LiDAR Quality Assurance (QA) Report
Eastern Shore Virginia (ESVA) LiDAR Project
USGS
November 16, 2011

Submitted to:
USGS

Contract:
G10PC00013

The following LiDAR quality assurance report documents Dewberry's fourth review of LiDAR data and derived products for the Eastern Shore Virginia LiDAR Quality Assurance Project. The report identifies areas where issues have been corrected as well as describing some end results of the data that may look unnatural but have been deemed acceptable by project participants. Each tile contains LAS point cloud data classified according to the USGS LiDAR Guidelines and Base Specifications, version 13 classification scheme. The final deliverables also include an ESRI Geodatabase containing hydrographic breaklines and tiled hydro-flattened digital elevation models (DEMs).

Figure 5-Tile LAS_S23_3853_20, Delivery 1. Ground density model showing an area of aggressive classification along the coast.

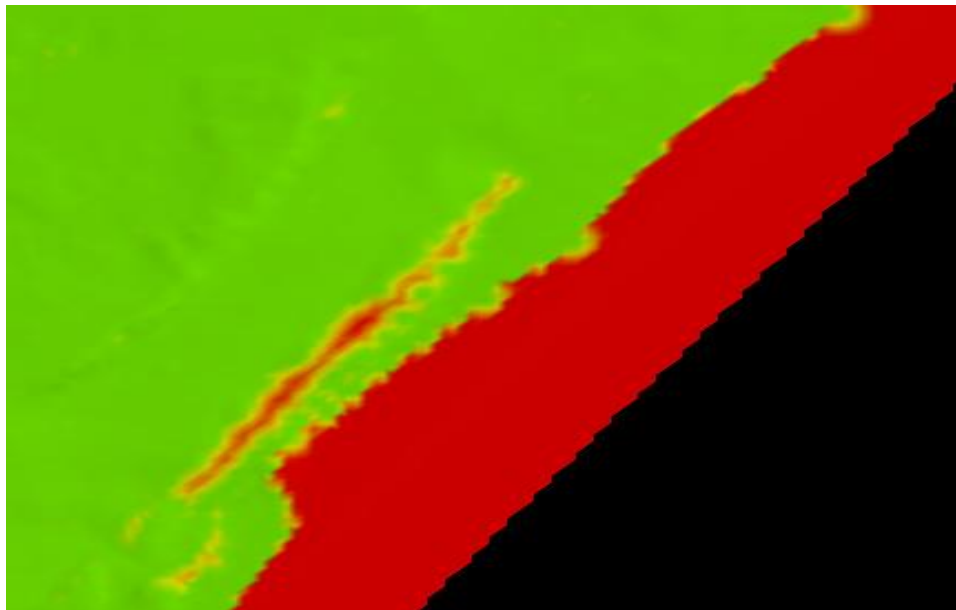
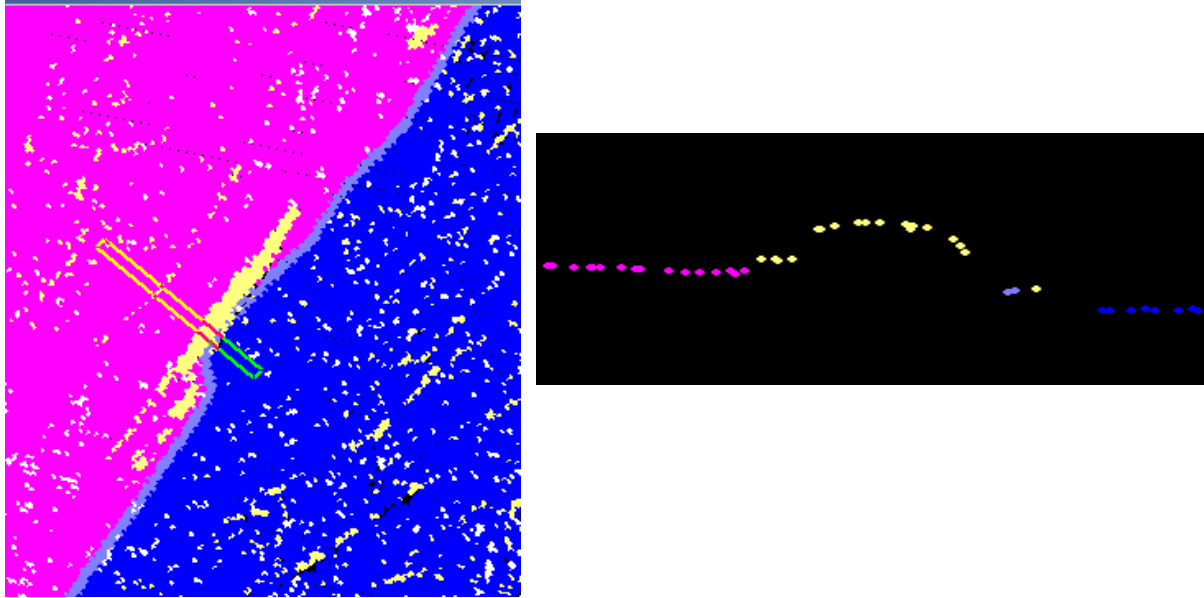
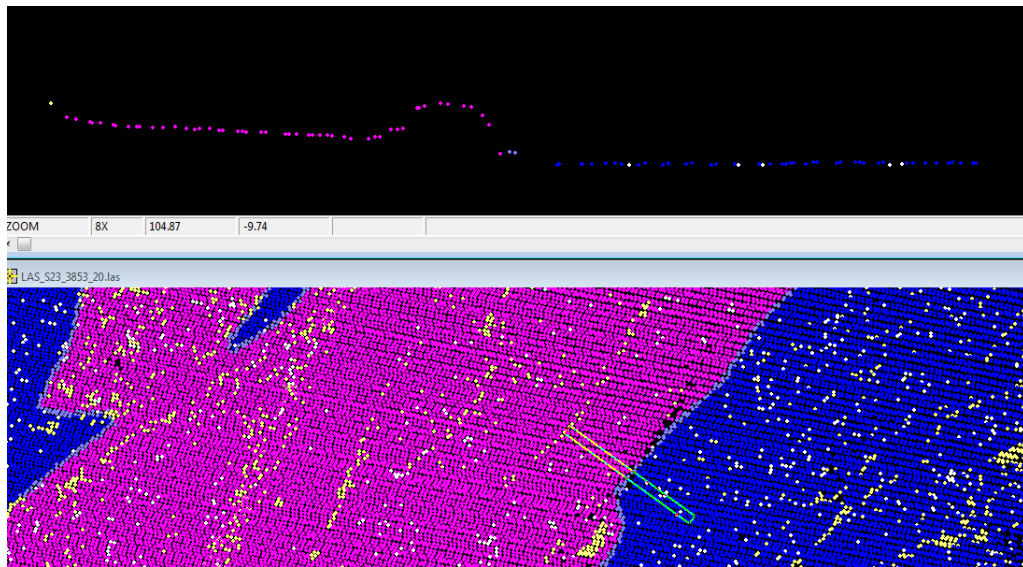
The first review of the Eastern Shore of Virginia LiDAR dataset identified multiple areas of aggressive classification. Most of the areas of aggressive classification occurred where legitimate ground points on a slope, such as along the bank of a hydrographic feature or a road embankment, were removed from ground and resulted in the loss of ground definition. Sanborn addressed all edit calls that impacted the final bare earth surface. Edit calls for aggressive classification that were minor and did not impact the final bare earth surface may not have been corrected or modified. Examples from the first and last deliveries are shown below.

Figure 6-Tile LAS_S23_3853_20, Delivery 1. Profile view of an area along the coast that was aggressively classified. An embankment was missing from the ground surface because these points had been incorrectly classified as class 1 (unclassified, yellow) but should have been classified as class 2 (ground, pink).

Figure 7-Tile LAS_S23_3853_20, Delivery 4. Profile view of an area along the coast that was aggressively classified, but has been corrected. Points representing an embankment had previously been classified as class 1 (yellow) but are now classified as class 2, ground (pink). This correction has added detail to the ground model.

Figure 8-Tile LAS_S23_2786_40, Delivery 1. Ground density model showing a void was present in the bare earth surface model. As the profile below shows, this void was a result of ground points being misclassified as class 1, unclassified.

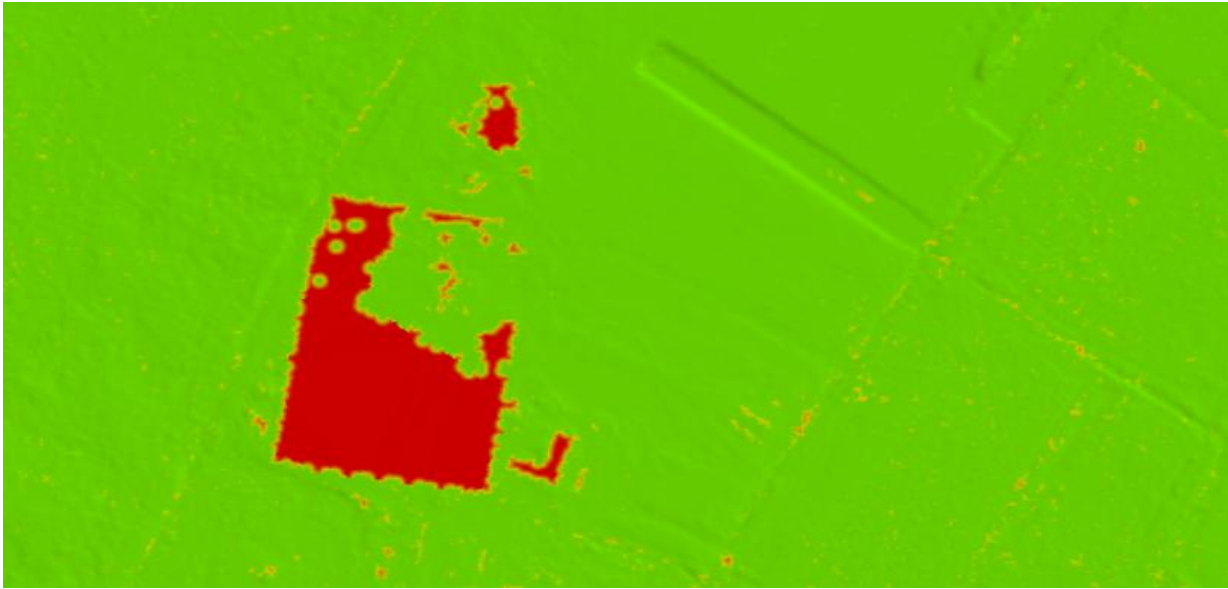
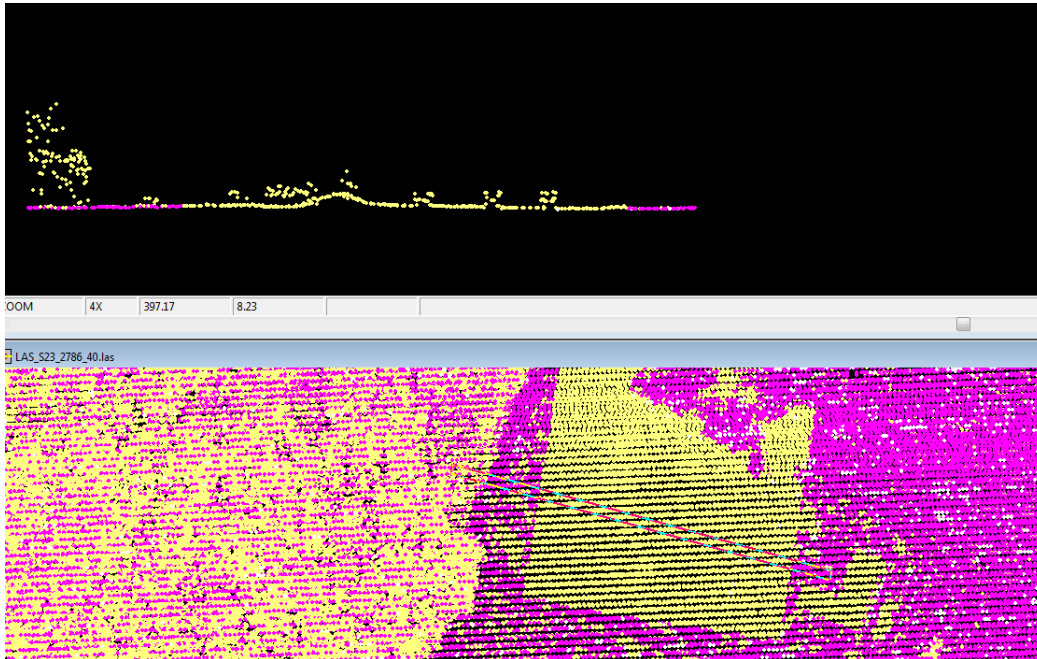
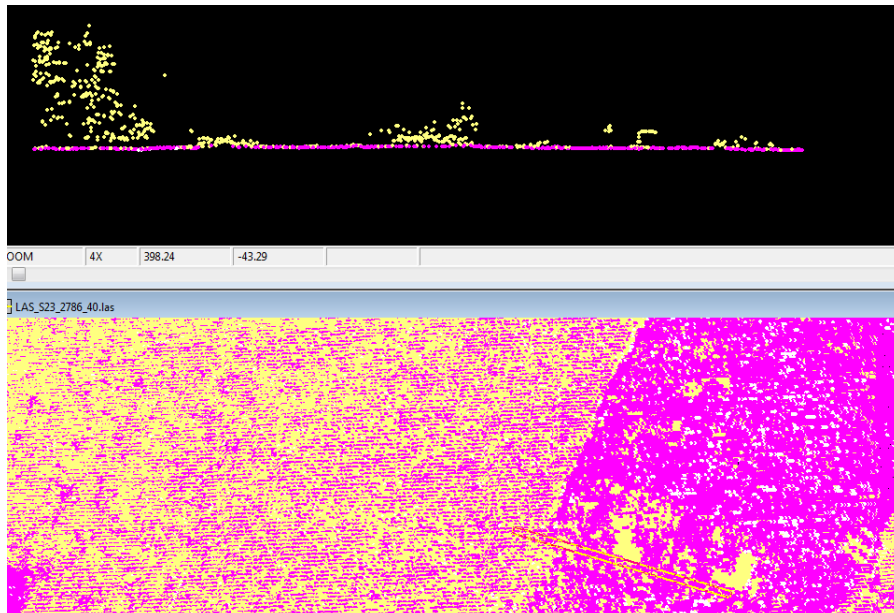
The first review highlighted multiple areas where ground points (class 2, pink) were misclassified to unclassified (class 1, yellow) or ground points were misclassified to water (class 9, blue). Sanborn addressed all edit calls that impacted the final bare earth surface. Edit calls for misclassification that were minor and did not impact the final bare earth surface may not have been corrected or modified. Examples from the first and last deliveries are shown below.

Figure 9-Tile LAS_S23_2786_40, Delivery 1. Profile view of points displayed by classification, showing points that were classified as unclassified (class 1, yellow) should have been classified as Bare Earth (class 2, Pink).

Figure 10-Tile LAS_S23_2786_40, Delivery 4. Profile view of points displayed by classification, showing legitimate points that were classified as unclassified (class 1, yellow) have been corrected by Sanborn and are now classified as Bare Earth (class 2, Pink).

Figure 13, all deliveries-Tidal breaklines are shown in purple, overlaid on the vcr_land_area" shapefile that identifies the extent of land that is used as a boundary for the USGS ESVA project. As the screenshot shows, tidal breaklines run through the middle of islands and appear unnatural.

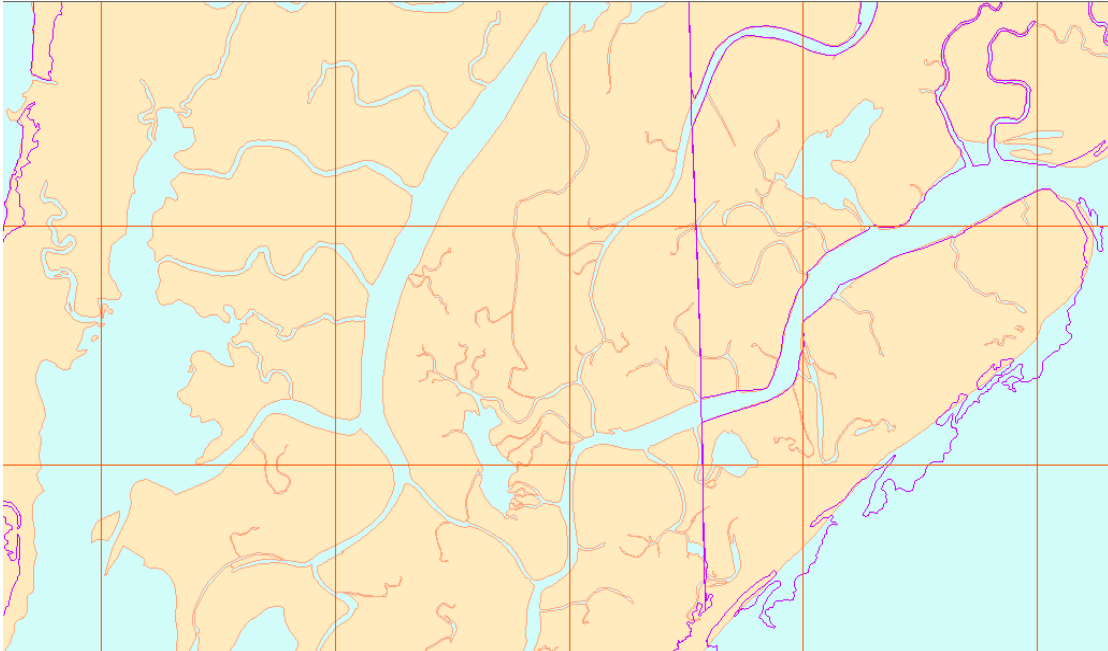
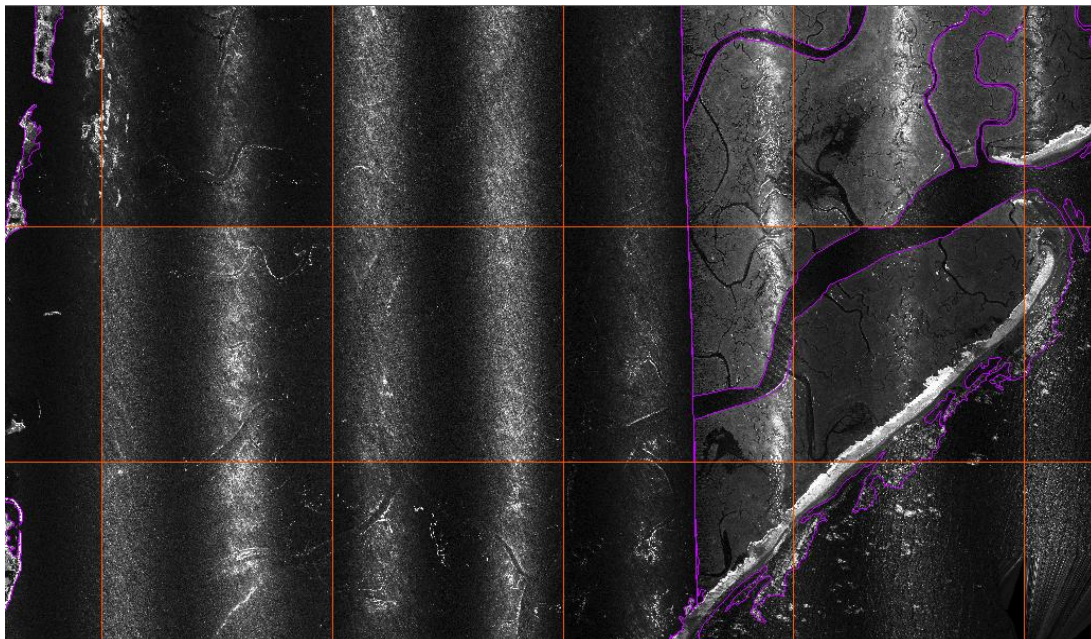
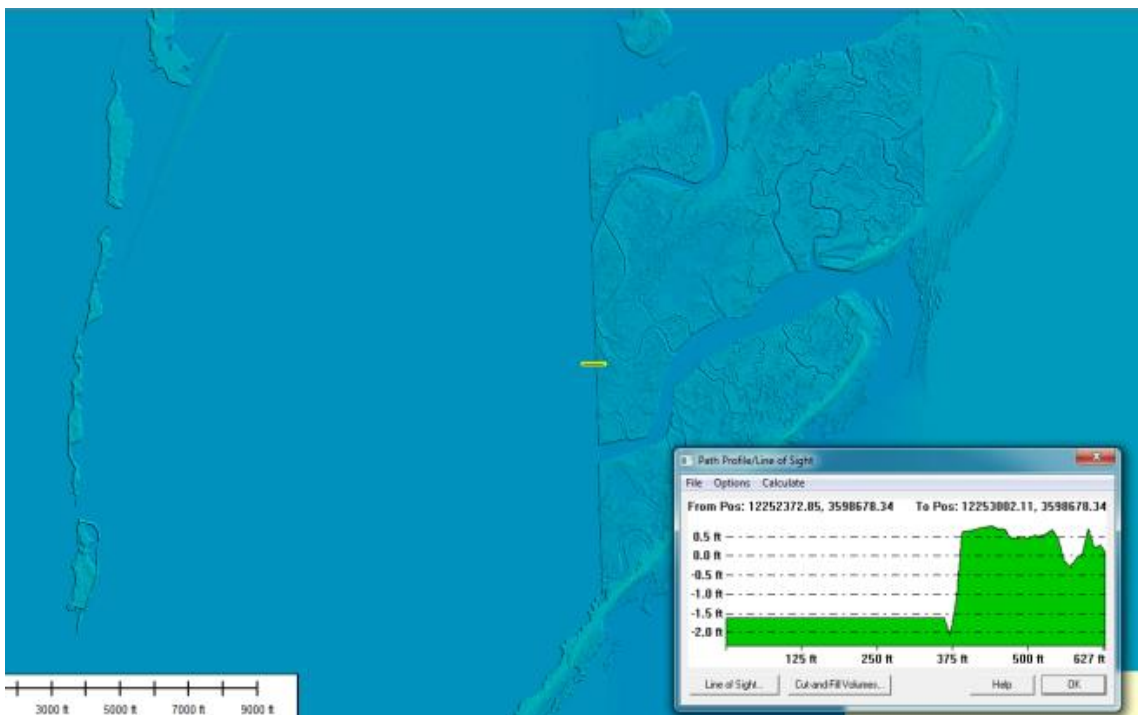
The entire coastline of this project area, which consisted of Accomack and Northhampton Counties, is tidally influenced. Differing tide levels can cause elevation changes within one flight line and can cause substantial elevation changes between flight lines. There are many low-lying islands off the coast of Accomack and Northhampton Counties. Many of these islands are only exposed at low tide. This caused some discontinuity in the data from one flight line to the next when an island is exposed in one flight line but inundated in the neighboring flight line.

This resulted in tidal breaklines that show abrupt changes between land and water interfaces. These breaklines often do not appear natural. However, this phenomenon is related to tidal fluctuations as Sanborn was not required to collect data at low tide.

Figure 14, all deliveries-Tidal breaklines are shown in purple overlaid on intensity imagery. As the screenshot shows, the tidal breaklines follow the land water interface as seen in the intensity imagery.

Figure 15, all deliveries-Tile LAS_S23_2559_20. Point cloud displayed by flight line source id. Flight line edges correspond to the land water interface seen in the intensity imagery and reflected in the breakline collection.

Figure 16, all deliveries-DEMs of the same area shown in the screenshots above. DEMs also seem to show an “unnatural” break between land and water interfaces due to large tidal variations between flight lines. While the water on the left side of this image is actually higher than the exposed island on the right side of this image, the water must be flattened and given a lower elevation. Otherwise, the water will appear as floating above surrounding land.

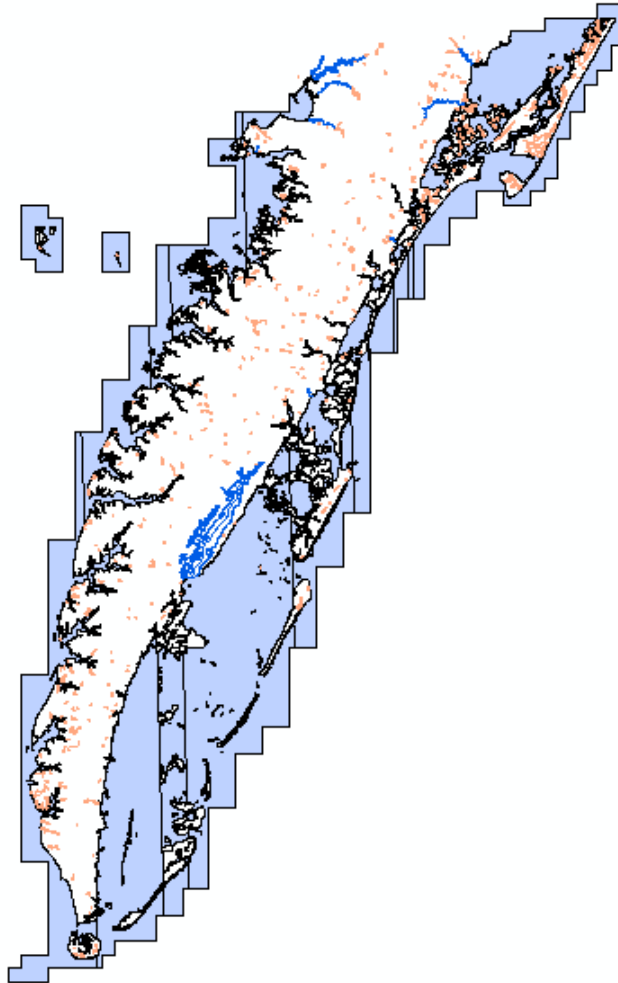
Normally, Dewberry asks that adjacent polygons be merged together into one feature. This is normally more organized and creates a cleaner line for the breakline data. However, due to tidal variations between adjoining flight lines, Sanborn has kept each tidal water area within a flight line as a separate polygon. Having Tidal Waters as separate polygons for each flight line helped immensely during the QA review as this area can be complicated, especially with tidal variations that can be drastic from one flight line to the next. Due to the usefulness of the separate polygons, Dewberry did not mark edit calls for “unnecessary polygon boundaries” in the Tidal Waters as is listed in the Breakline QA/QC Checklist. Below is a screenshot of the Tidal Water breaklines that are split at flight line boundaries.

Figure 17, all deliveries-Tidal Water polygon breaklines are shown in light blue with a black outline. Normally Dewberry uses the PLTS “unnecessary polygon boundaries” check to identify adjacent polygons that should be merged into one. Due to the drastic tidal variations between flight lines, having the Tidal Waters split at those boundaries was very useful during the QA review. Because it could be useful for end users to have the Tidal Water breaklines split at flight line boundaries, Dewberry did not run the unnecessary polygon boundaries check on Tidal Waters.

Figure 18-Tile S23_4900_40, Delivery 1. Island was not collected that is large enough to meet USGS specifications.

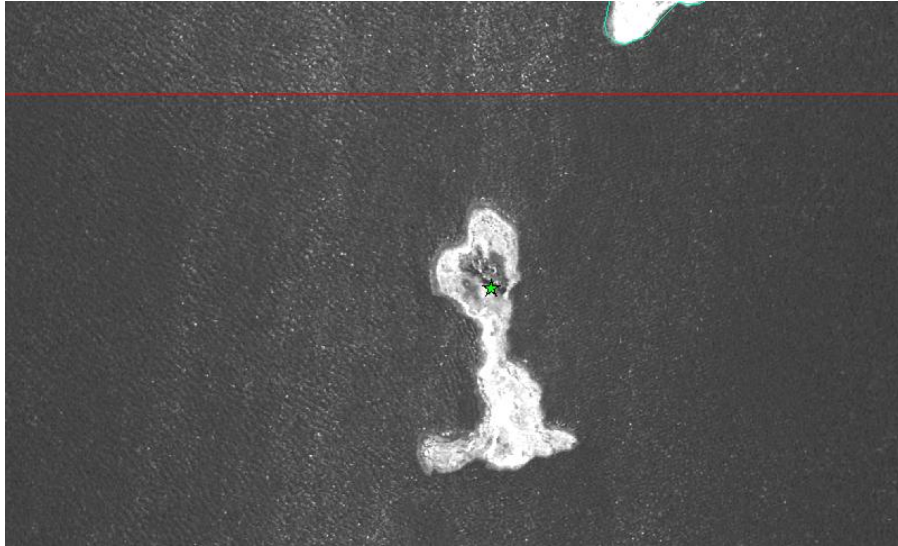
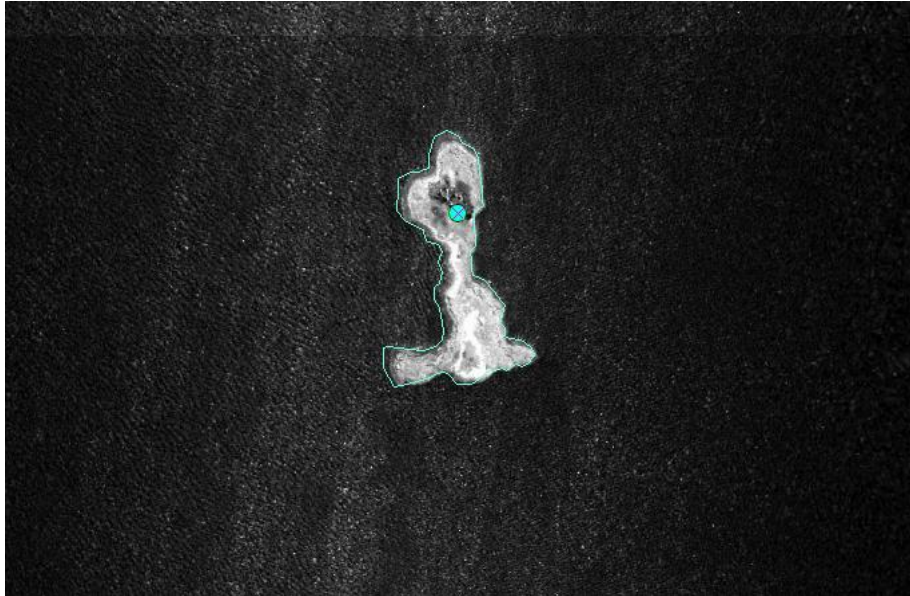
Islands that meet USGS capture specifications of .5 acres should be collected as “holes” and excluded from polygon layers, such as Inland Ponds and Lakes or Tidal Waters. Forty-eight (48) features were identified as missing in the first delivery. Sanborn has addressed these edit calls. An example is shown below.

Figure 19-Tile S23_4900_40, Delivery 4. Island has been collected.
